Subject: Response to Need for Continued Extraction for Containment  
Site ST012 - Former Williams Air Force Base (AFB), Mesa, Arizona

**Attachment 1**  
**Responses to EPA/ADEQ Joint Letter – Need for Continued Extraction for Containment at**  
**ST-12 Fuels Spill Site, Former Williams AFB, Mesa, AZ**

**Attachment 2**  
**Responses to EPA April 29, 2016 email questions**

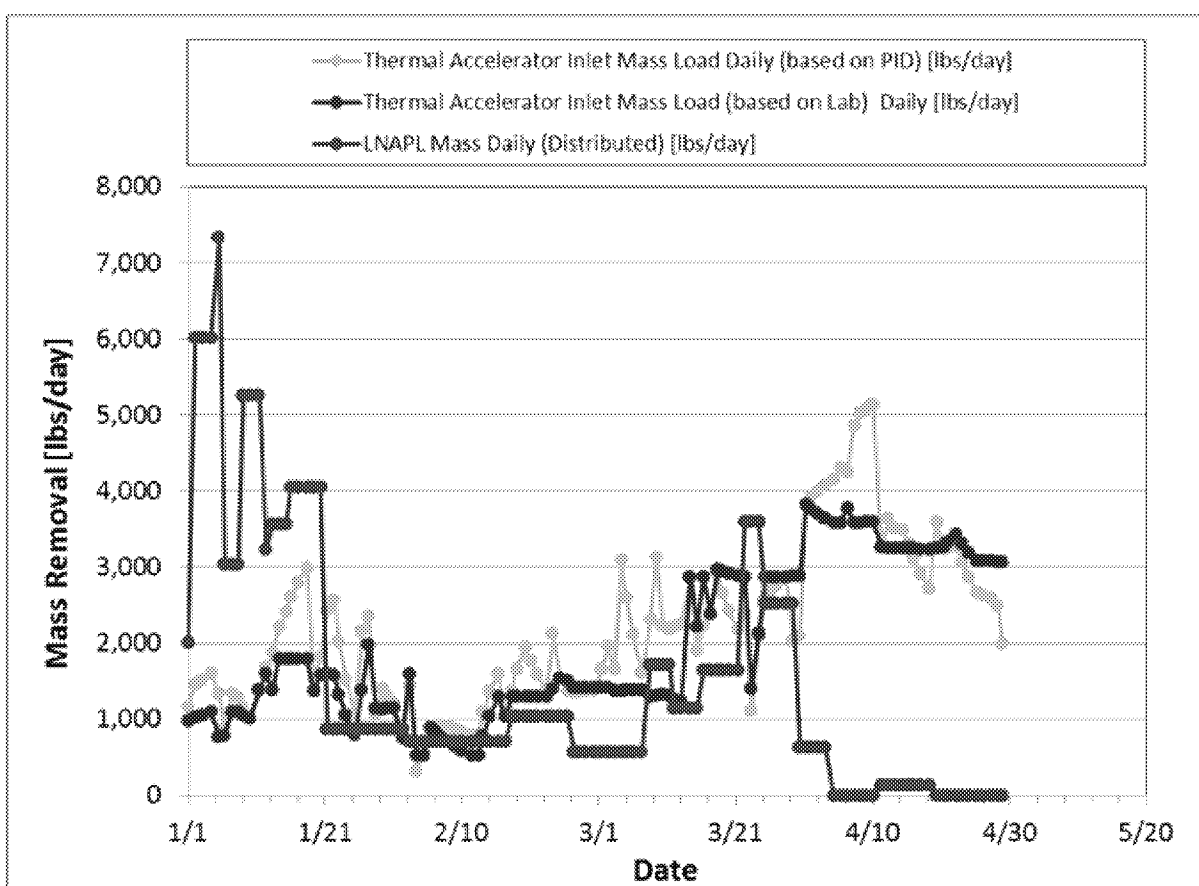
- b. “The contaminant sources for the recent vapor mass recovery (dissolved phase and volatilized contaminants in extracted steam or air) are likely masses of residual LNAPL remaining in the TTZ (and other soil volumes previously heated to steam temperature).”

*Response: In the last week of post-steam extraction, a study was conducted to evaluate where the vapor mass was originating. The extraction system was sequentially operated through a sequence to isolate each zone and take PID and flow rate measurements. Time was provided (approximately 45 to 60 mins) to allow flushing of the vapor system. The sequence of tests was as follows:*

*A graph presenting the PID readings at the thermal accelerator influent is provided below.*

*This data indicates that the CZ is contributing most of the mass in the vapor phase since the vapor mass removal rate when only the CZ was open to extraction was close to the mass removal rates during normal operations (vapor and liquid extraction) and vapor only extraction from all three zones. This observation is consistent with previous technical explanations because this zone has more open screen for vapor extraction available and vapors extracted through this zone would, in part, capture mass from the vadose zone (such as the deep vadose zone intervals addressed by the deep SVE well screens). This observation is not consistent with the agencies suggestion that masses of residual LNAPL within the TTZ are the likely primary source of vapor mass recovery. However, as discussed below, SEE wells will be checked and monitored for LNAPL.*

*It should be noted that some mass removal is observed in the vapor phase for both the UWBZ and the LSZ tests. This mass removal is likely due to the lack of complete isolation of those zones during the tests. If open screen is not available in either the UWBZ or the LSZ, isolation on one of those zones may encourage leakage at other wells that have been shut off but are all connected to the same piping manifolds.*
